ITEM FOR ENVIRONMENTAL COMMISSION AGENDA

COMMISSION MEETING DATE:	December 2, 2020
NAME & NUMBER OF PROJECT:	SP-2020-0228D Brushy Creek Regional Utility Authority Raw Water Pump Station
NAME OF APPLICANT OR ORGANIZATION:	Karen Bondy, General Manager Brushy Creek Regional Utility Authority
LOCATION:	9416 Lime Creek Road, Leander, Texas 78641
COUNCIL DISTRICT:	Council District does not apply in Extraterritorial Jurisdiction
ENVIRONMENTAL REVIEW STAFF:	Jonathan Garner, Environmental Program Coordinator, Development Services Department, (512) 974-1665, Jonathan.Garner@austintexas.gov
WATERSHED:	Lake Travis Watershed, Water Supply Rural Classification, Drinking Water Protection Zone
REQUEST:	<p>Variance requests are as follows:</p> <ol style="list-style-type: none">1. Request to vary from LDC 25-8-301 to construct private driveways crossing slopes in excess of 15 percent gradient.2. Request to vary from LDC 25-8-302(A) to construct a surface parking lot on slopes in excess of 15 percent gradient.3. Request to vary from LDC 25-8-302(B) to construct a building on slopes in excess of 25 percent gradient, and exceed impervious cover allowance on slopes with a gradient of more than 15 perce

FILL EXHIBIT

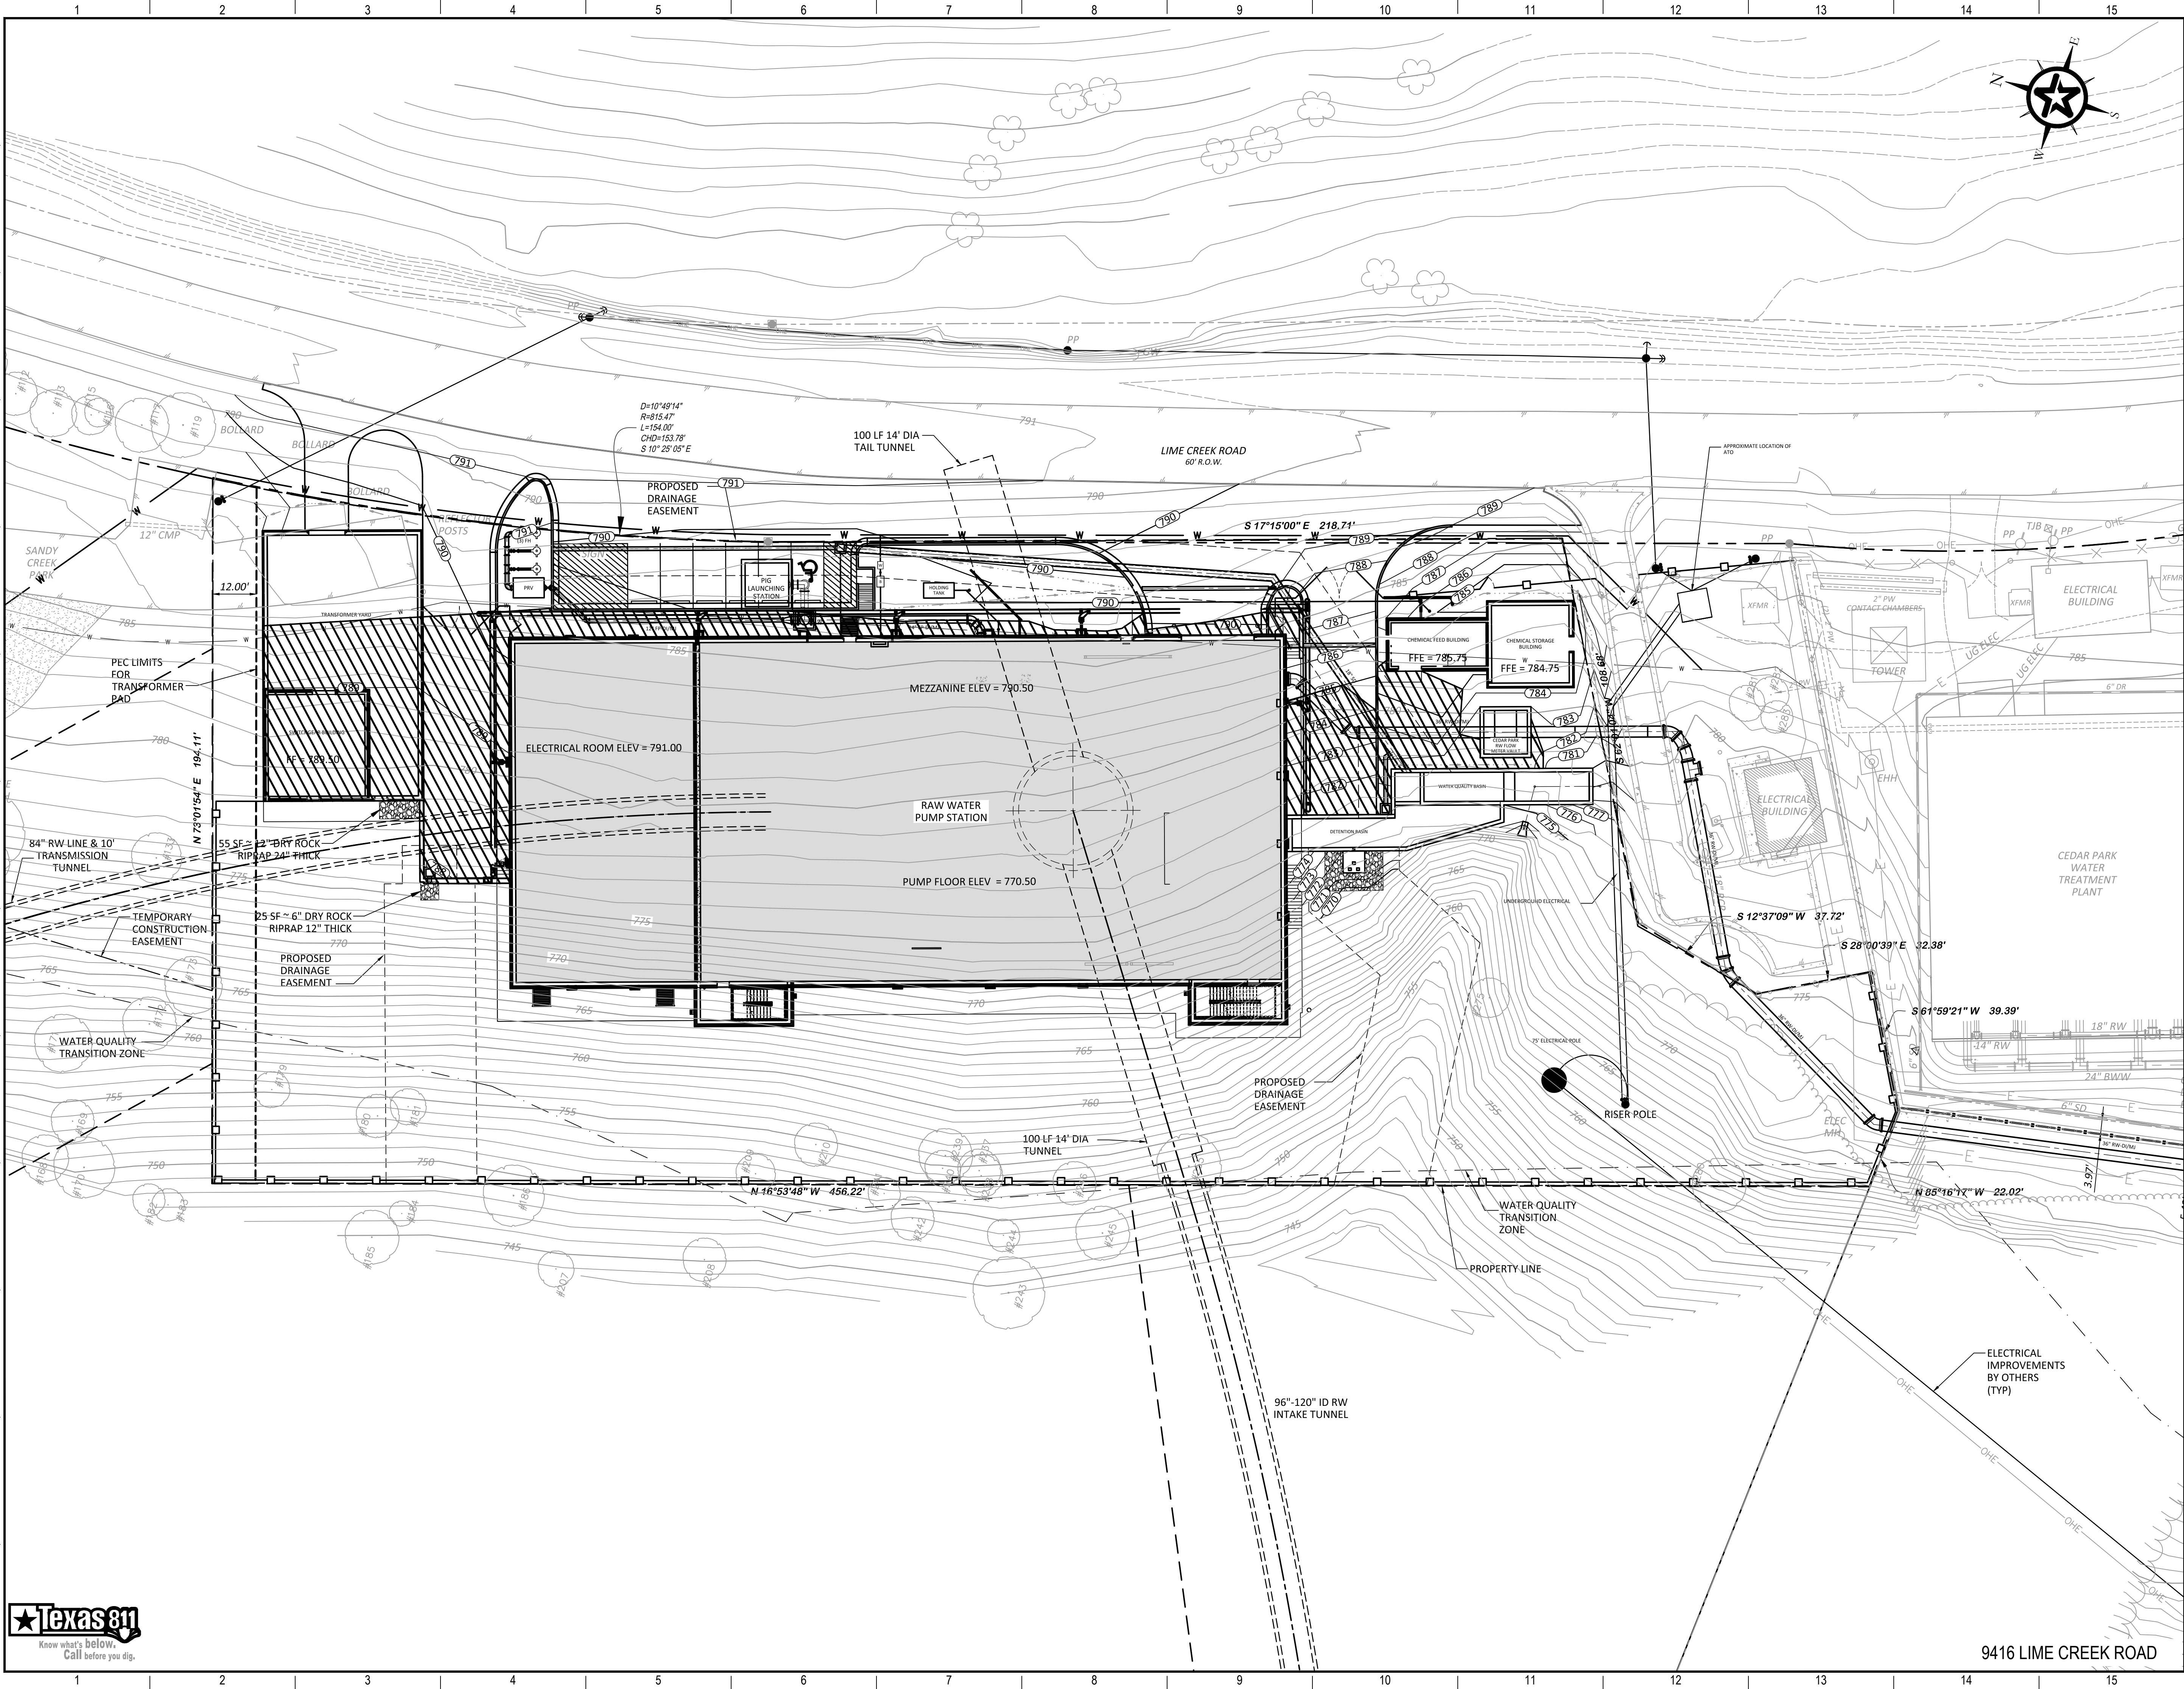
The surface parking and drive/fire lanes are the only site features that require the excess fill material, to the extent as needed to satisfy the

maximum allowed gradient set by Travis County fire regulations (see Fill Exhibit, page 35). The surface parking lot and the building are sited on the least sloped areas of the site, and only propose the amount of square footage necessary for the functioning of the facility to meet the projected water demands and provide safe accommodations for the employees (see Slope Exhibit, page 36).

RESTORATION EXHIBIT

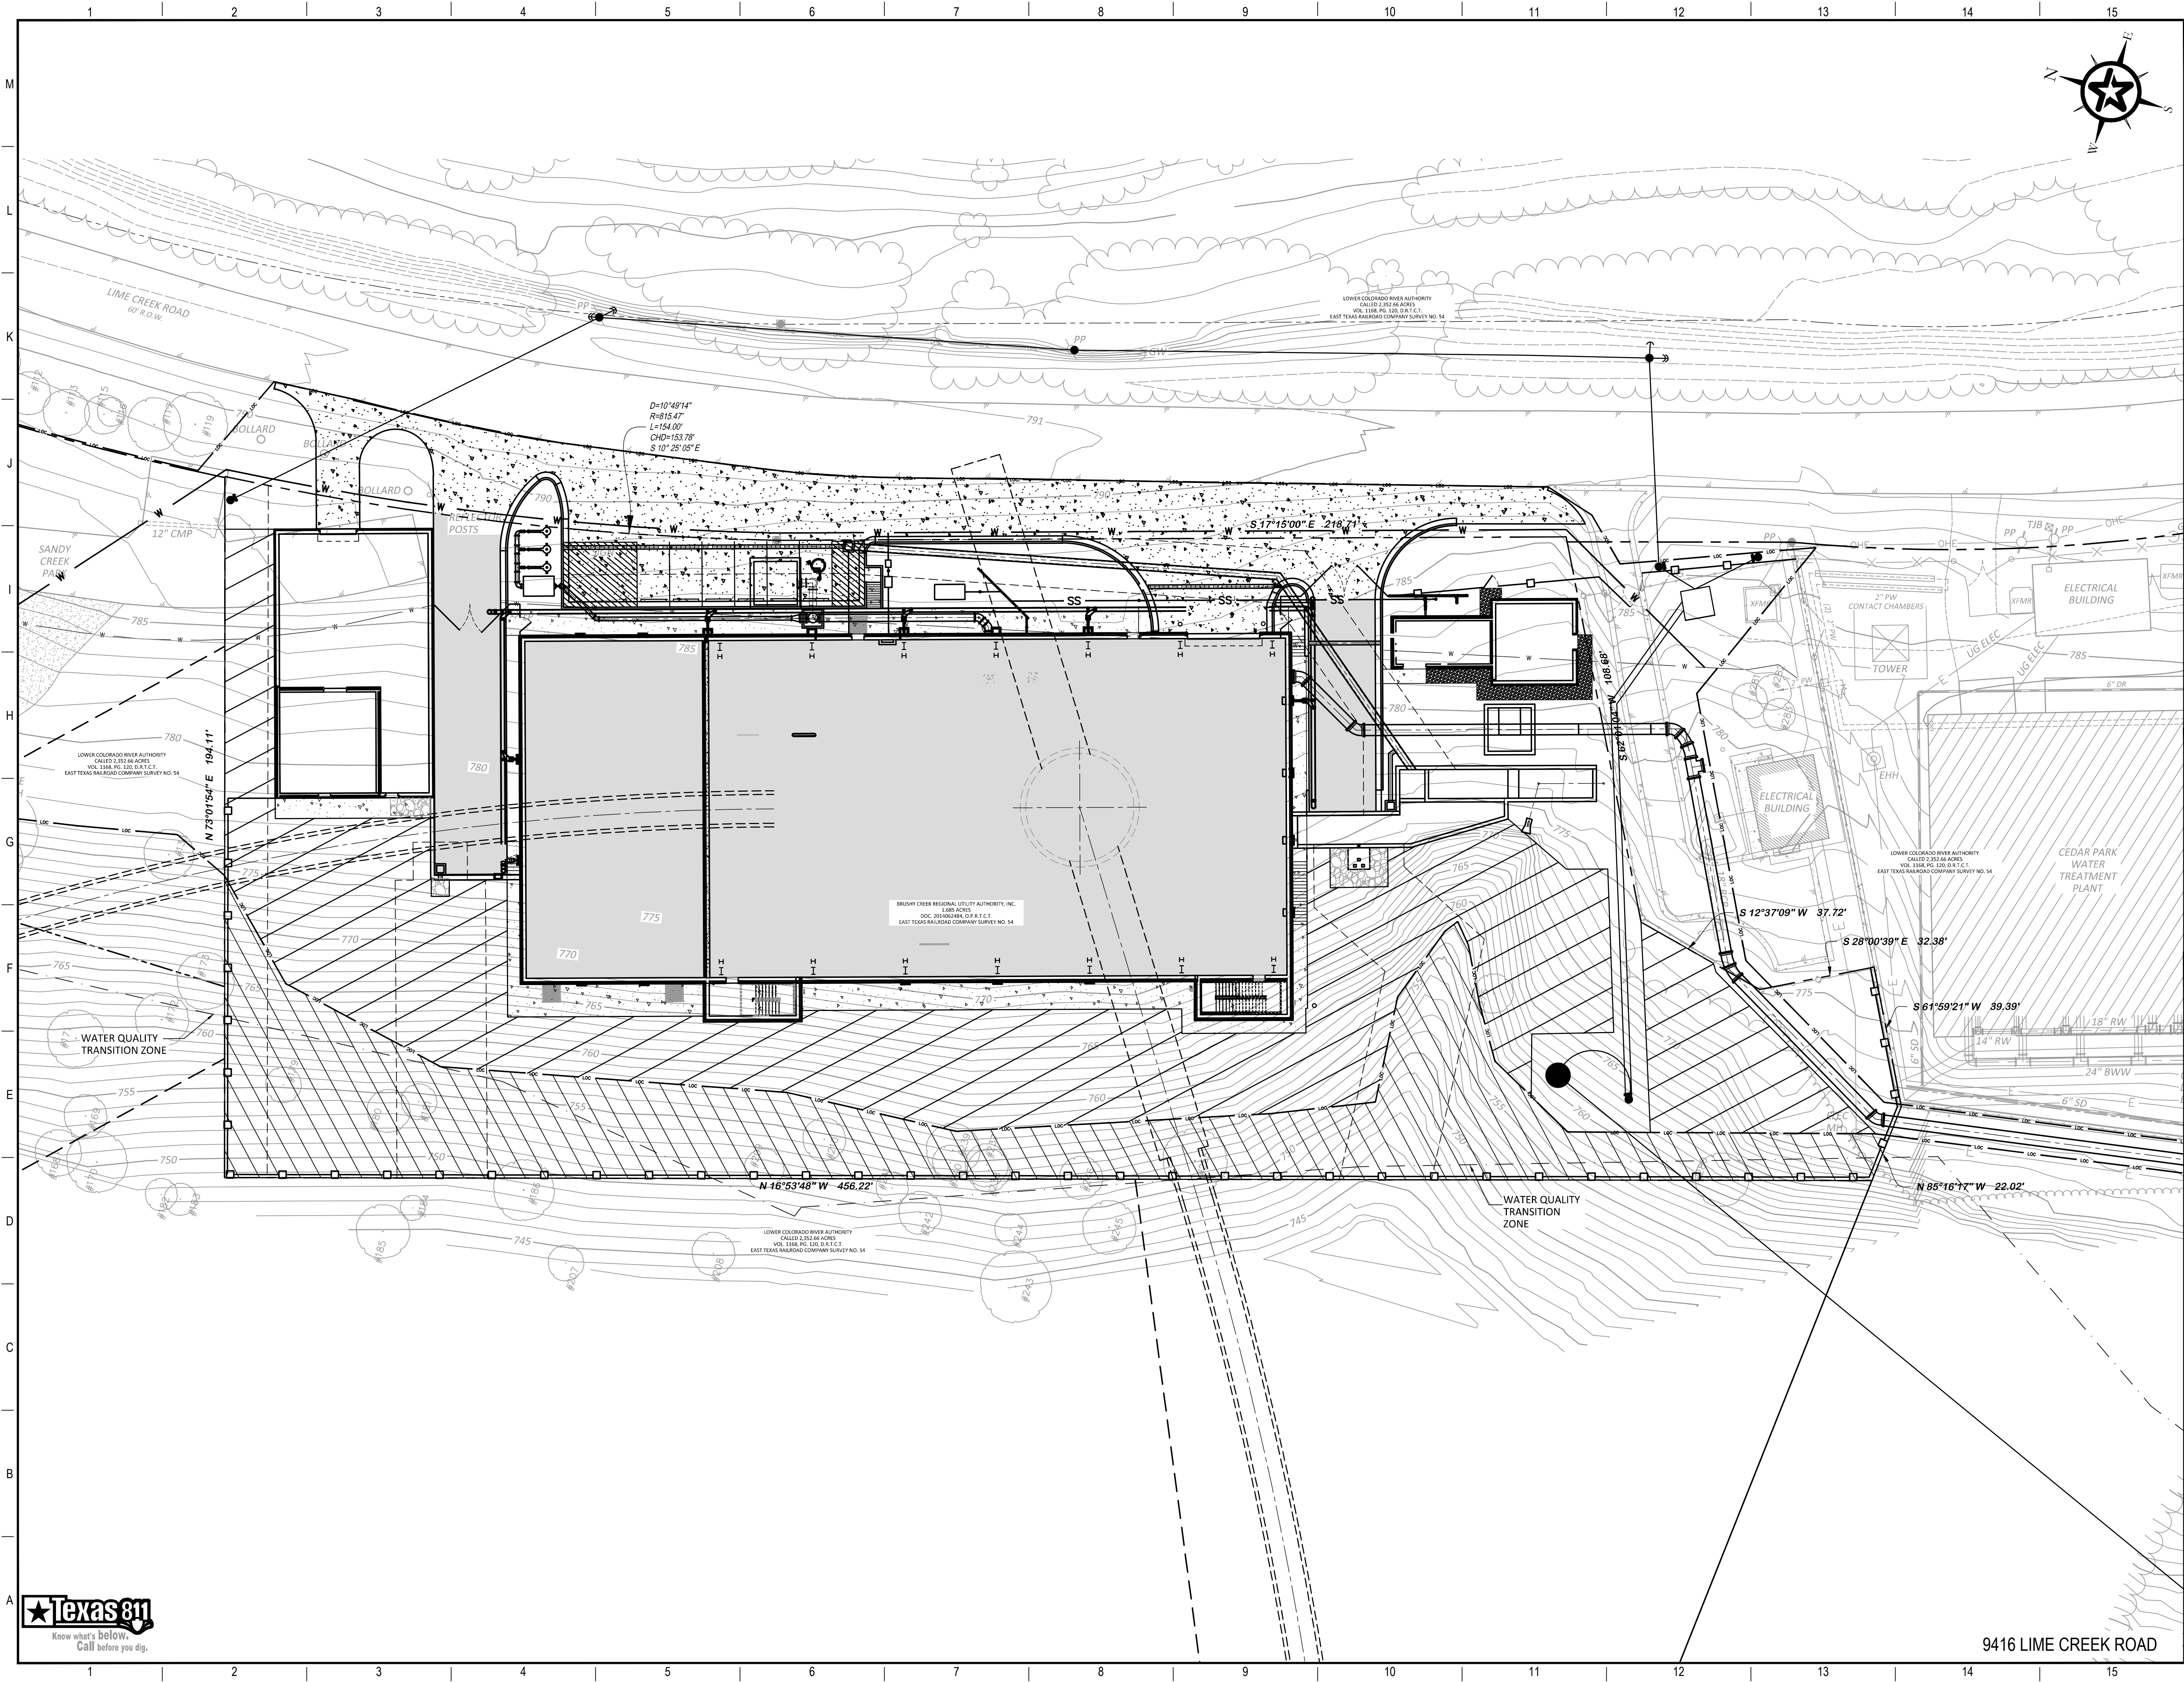
Yes. The proposed development will be treating stormwater runoff from the impervious cover on-site, providing permanent erosion and sedimentation controls to minimize or eliminate erosion downgradient of the proposed development from entering Lake Travis, and will be providing water quality treatment and detention for a 2,500 s.f. area of off-site impervious cover from Lime Creek Road. The site will comply with the 40 percent natural area buffer located in the uplands and downgradient of the proposed site construction. This

buffer preserves and/or restores natural vegetation, soils, and topography to serve receive overland drainage from the developed areas for water quality benefits, and provides a natural vegetative buffer and setting for the developed area to fit more naturally into the landscape and be screened from lake users (see Restoration Exhibit, page 37).

1. Restoration of disturbed areas within the 40% Natural Area Buffer shall be subject to ECM Appendix A criteria;
2. Provide robust temporary and permanent erosion and sedimentation controls downgradient of the proposed development beyond the minimum standard;
3. Provide water quality and detention for an area of offsite impervious cover such that the total amount of impervious cover treated is comparable to only having 20 percent impervious cover onsite
4. Provide dense screening vegetation in compliance with ECM 2.9.0 for all pervious areas between the building and mechanical equipment and the right-of-way.
